PCN

Change of packaging for HVC25 series

Product / Process Change Notification

Previous inner box packaging		New inner box packaging

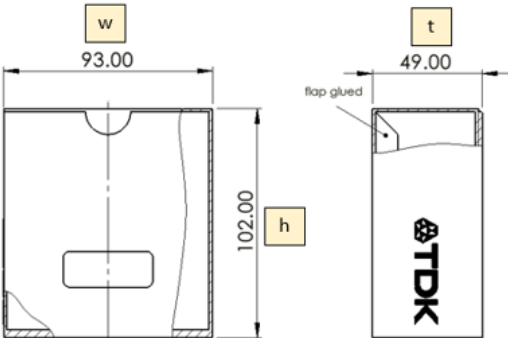
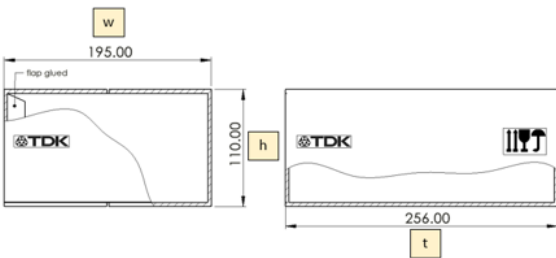
h	102 mm		98 mm
w	93 mm		93 mm
t	49 mm		48 mm

4. Description of change A new packaging of outer and inner box are being introduced for HVC25 series: The paper space will be removed to reduce the waste. Outer box packaging will be changed from h=110 mm x w=195 mm x t=256 mm to h=110 mm x w=199 mm x t=252 mm. Inner box packaging will be changed from h=102 mm x w=93 mm x t=49 mm to h=98 mm x w=93 mm x t=48 mm.

Previous outer box packaging		New outer box packaging

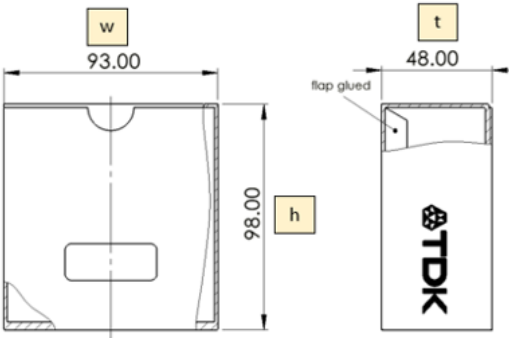
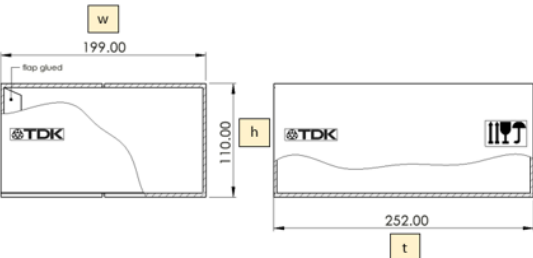
h	110 mm		110 mm
w	195 mm		199 mm
t	256 mm		252 mm
